TRAILS AT OVERLAND RANCH - SITE PLAN 1

SITE PLAN

COVER SHEET

SHEET TITLE:
TRACKING SHEET

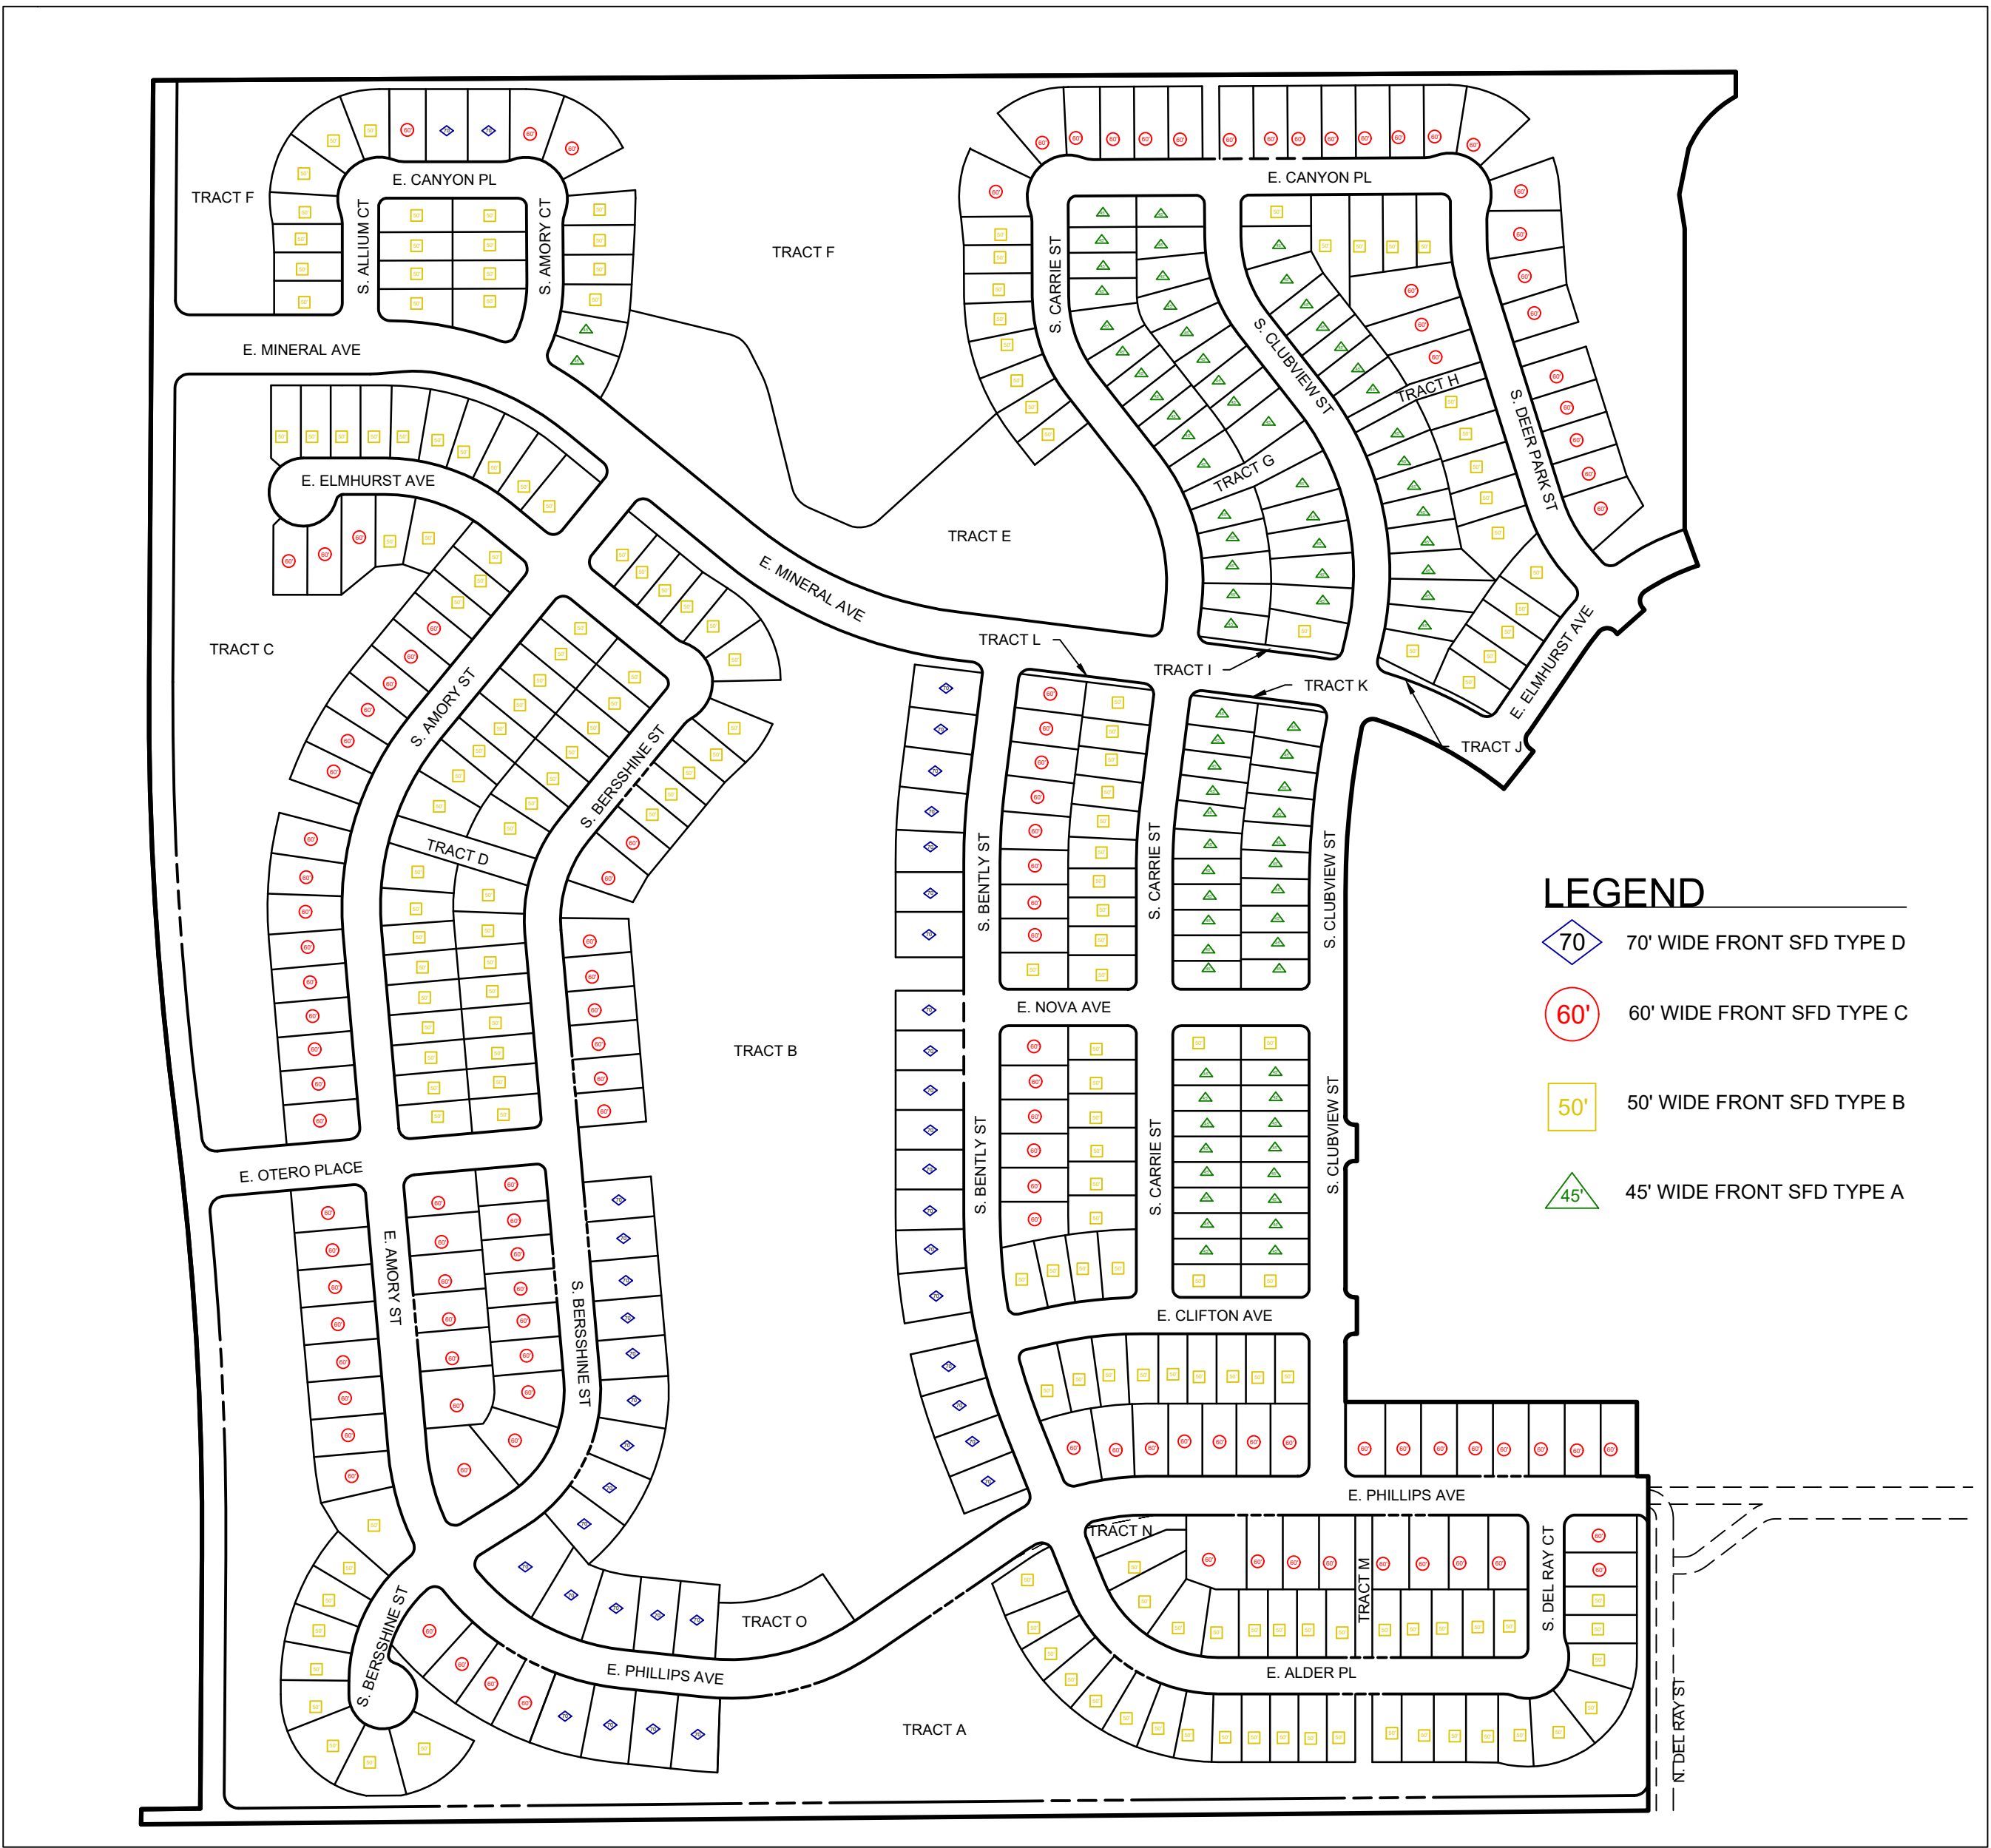
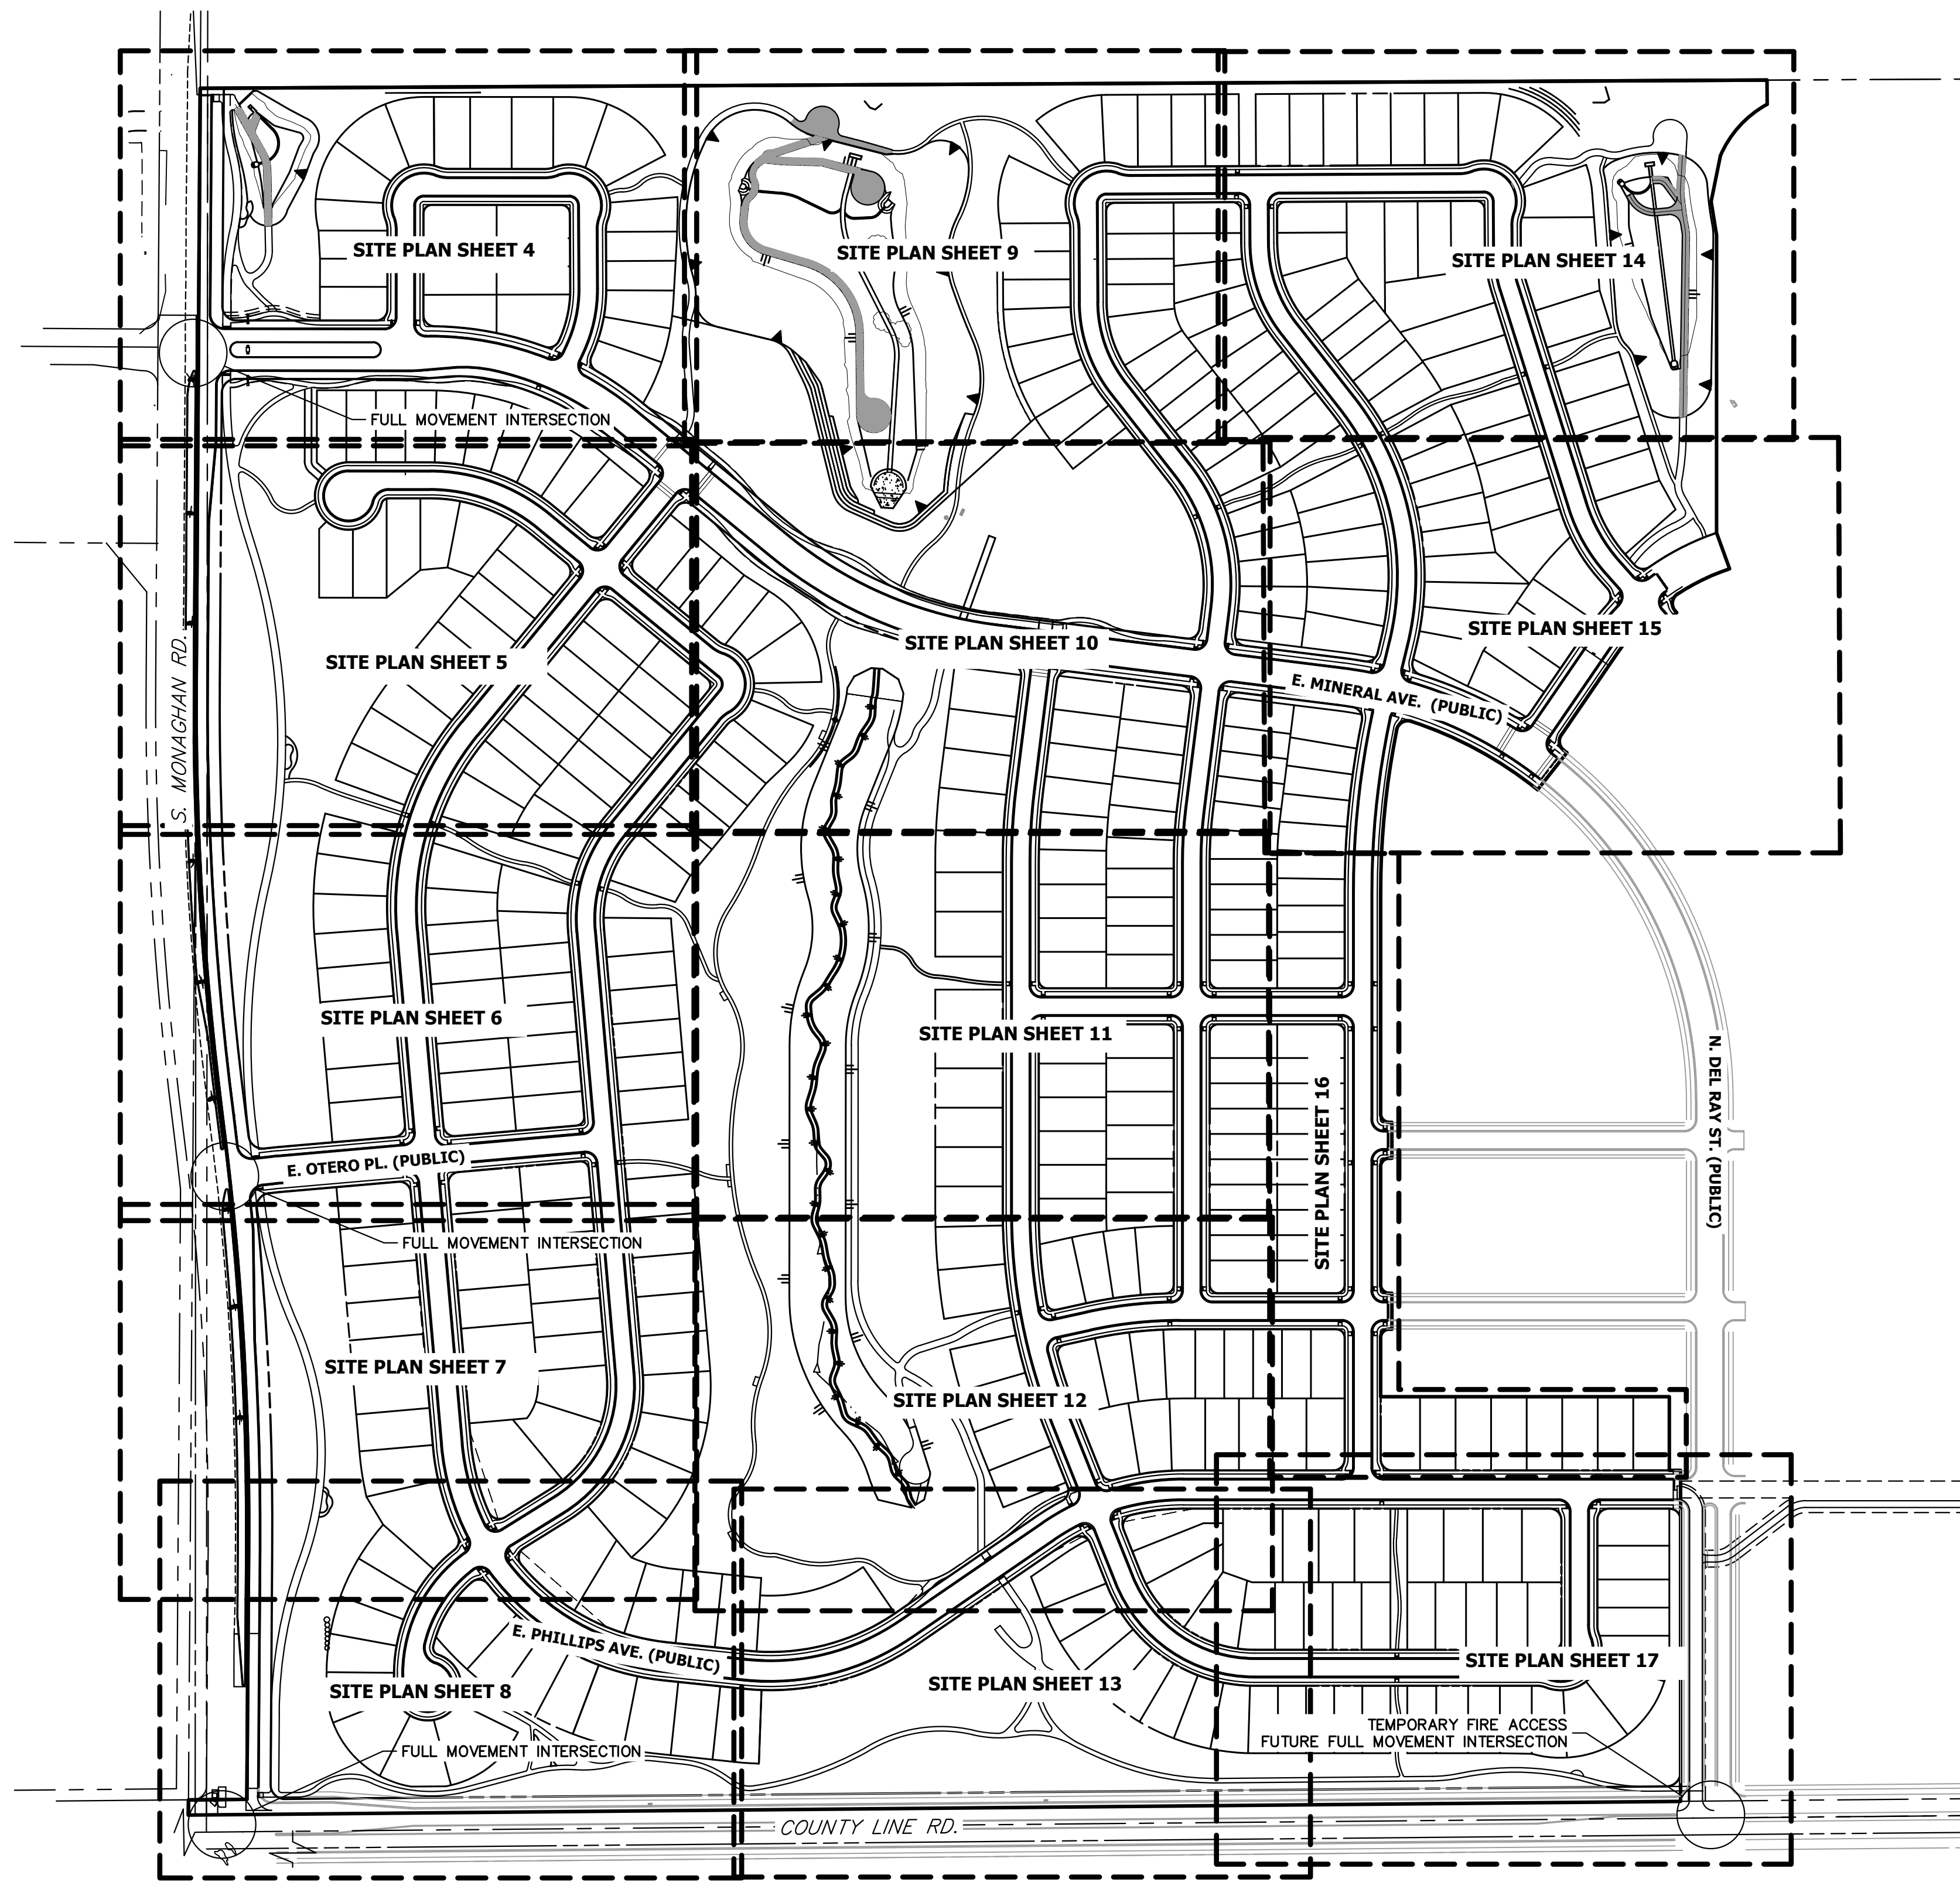
Thank you for identifying the mitigation measures in the comment response. Please provide a note on this sheet identifying which lots will require the mitigation measures and the two measures selected.

RESPONSE: MITIGATION MEASURES ADDED IN NOTE BELOW MAP DESCRIBING WHAT OCCURRED. A SYMBOL HAS BEEN ADDED TO THE MAP FOR WHERE THOSE MEASURES OCCURED.

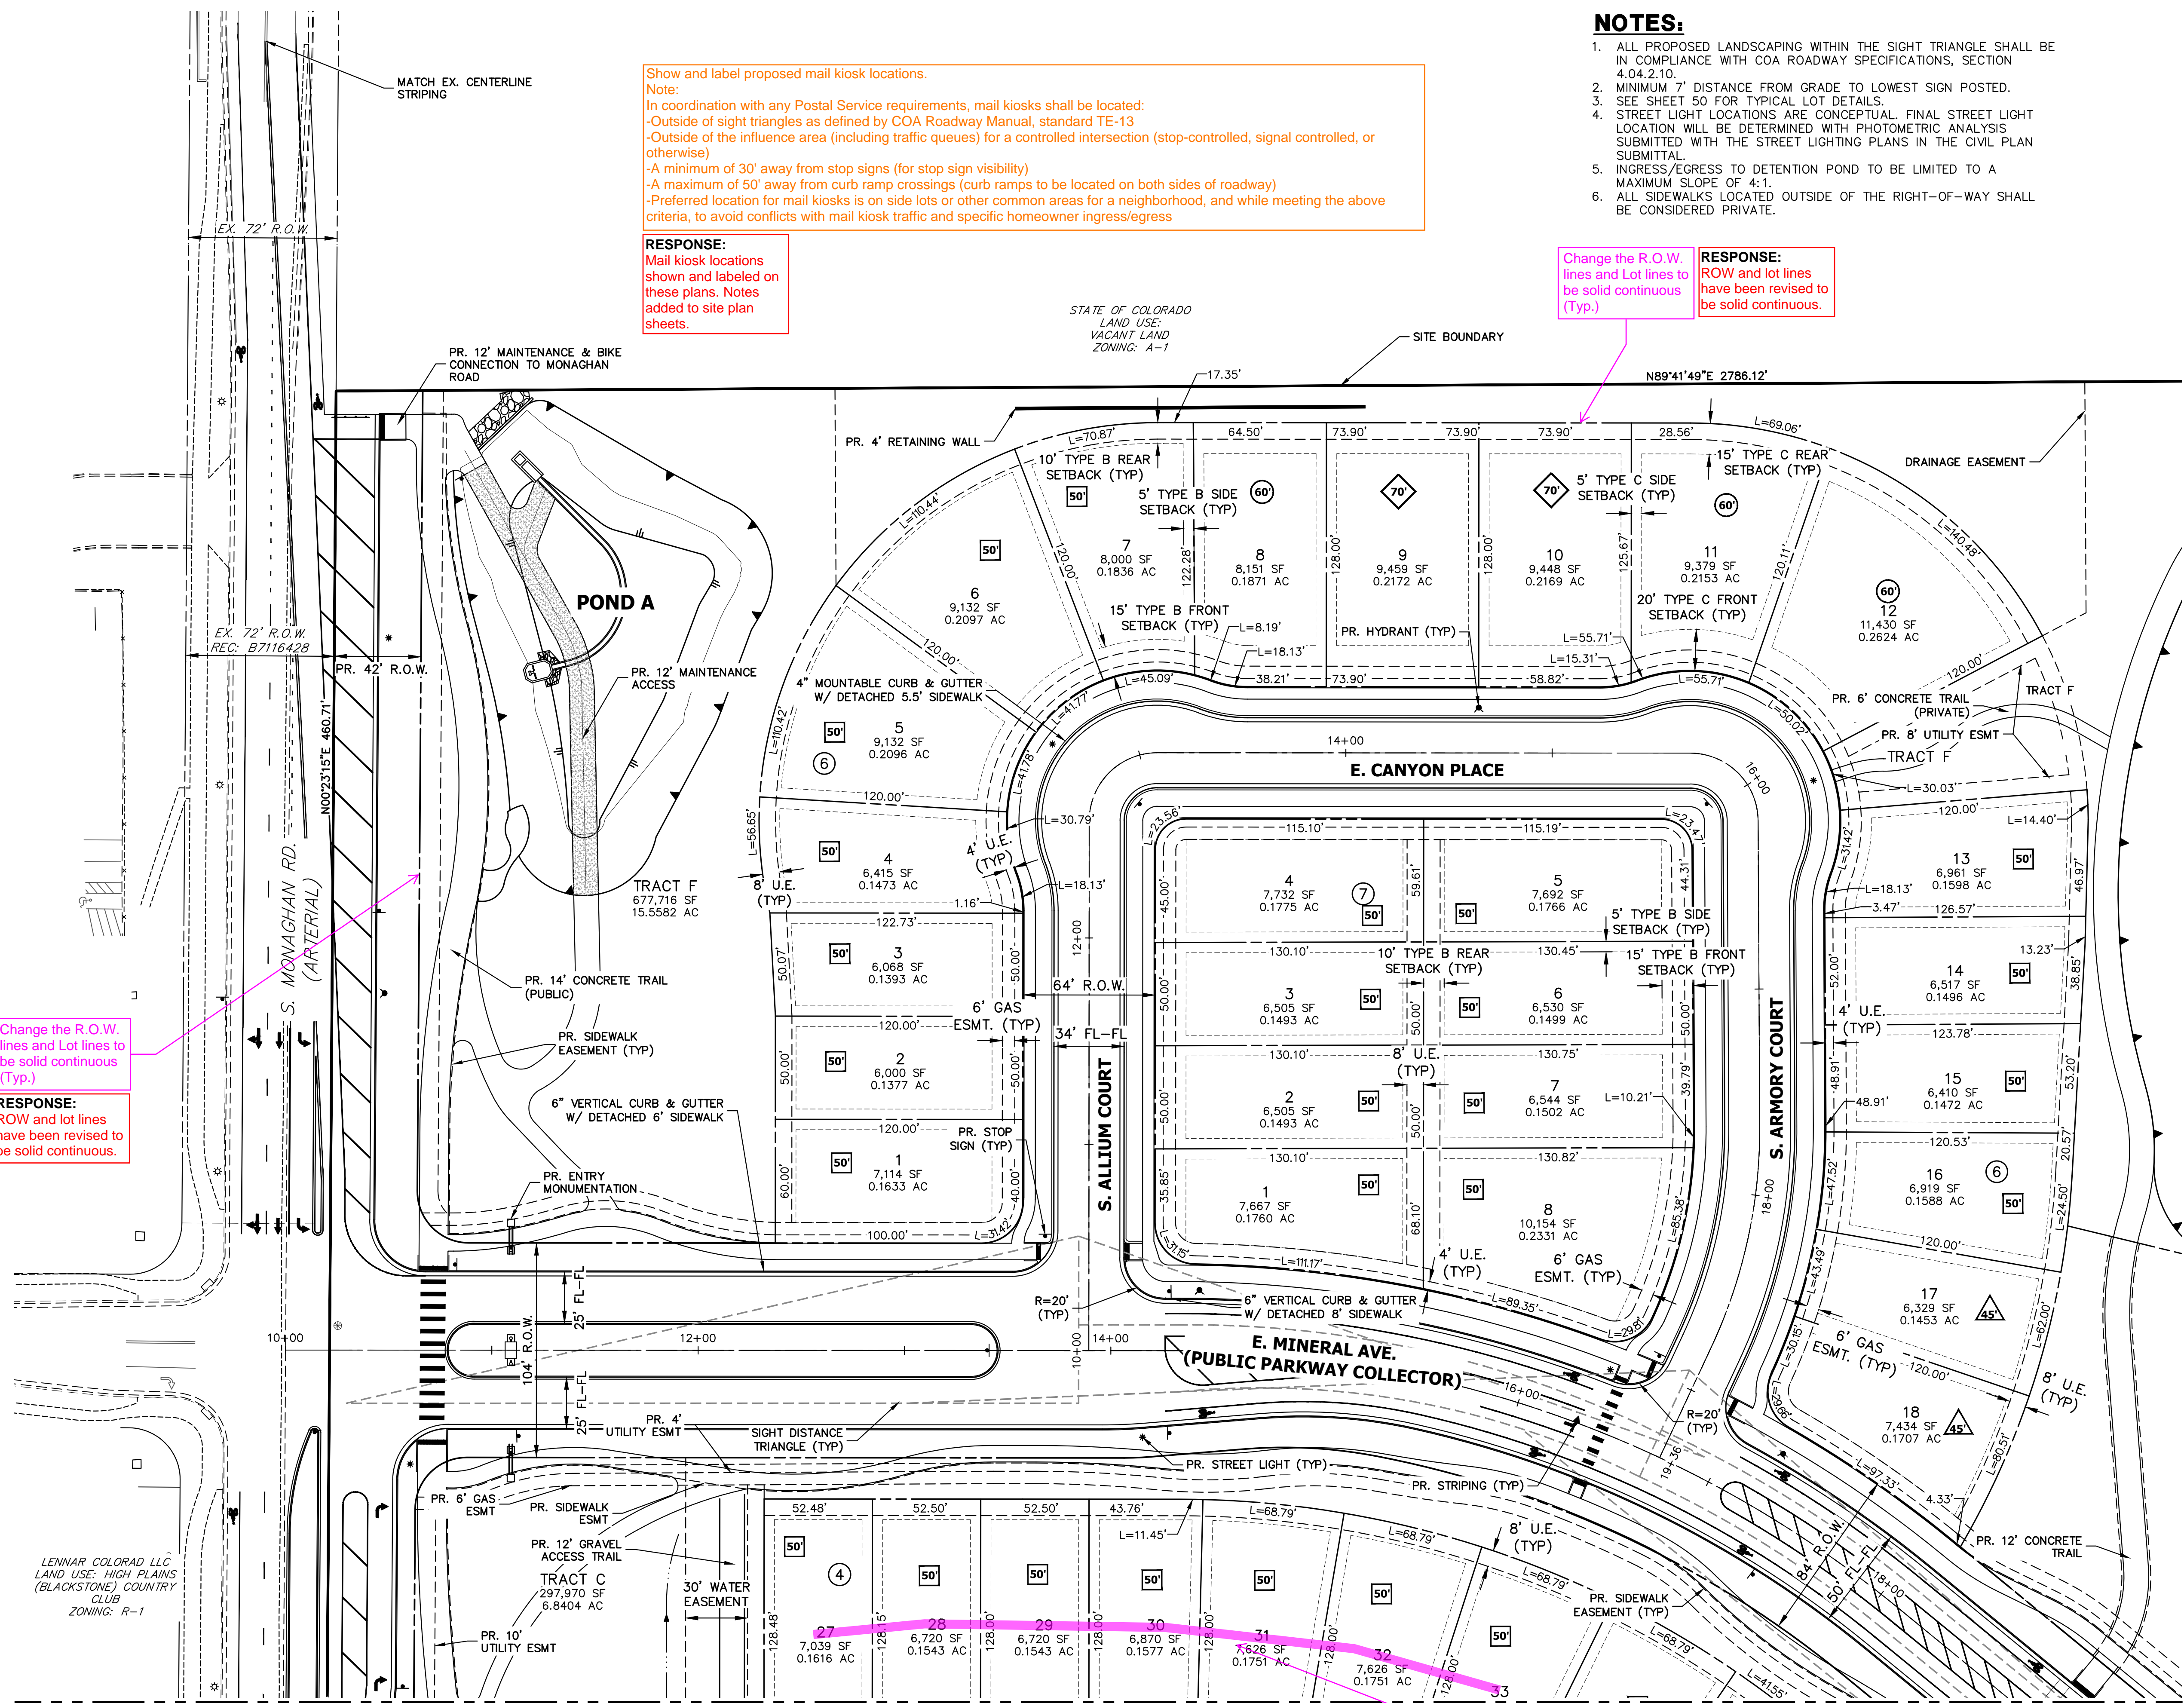
Show and label proposed mail kiosk locations.
Note:
In coordination with any Postal Service requirements, mail kiosks shall be located:
-Outside of sight triangles as defined by COA Roadway Manual, standard TE-13
-Outside of the influence area (including traffic queues) for a controlled intersection (stop-controlled, signal controlled, or otherwise)
-A minimum of 30' away from stop signs (for stop sign visibility)
-A maximum of 50' away from curb ramp crossings (curb ramps to be located on both sides of roadway)
-Preferred location for mail kiosks is on side lots or other common areas for a neighborhood, and while meeting the above criteria, to avoid conflicts with mail kiosk traffic and specific homeowner ingress/egress

Change the R.O.W. lines and Lot lines to be solid continuous (Typ.)

Change the R.O.W. lines and Lot lines to be solid continuous (Typ.)

revise these Lot numbers to be sequential with the rest of the block

RESPONSE:
Mail kiosk locations shown and labeled on these plans. Notes added to site plan sheets.

RESPONSE:
ROW and lot lines have been revised to be solid continuous.

RESPONSE:
ROW and lot lines have been revised to be solid continuous.

RESPONSE:
Updated numbering.
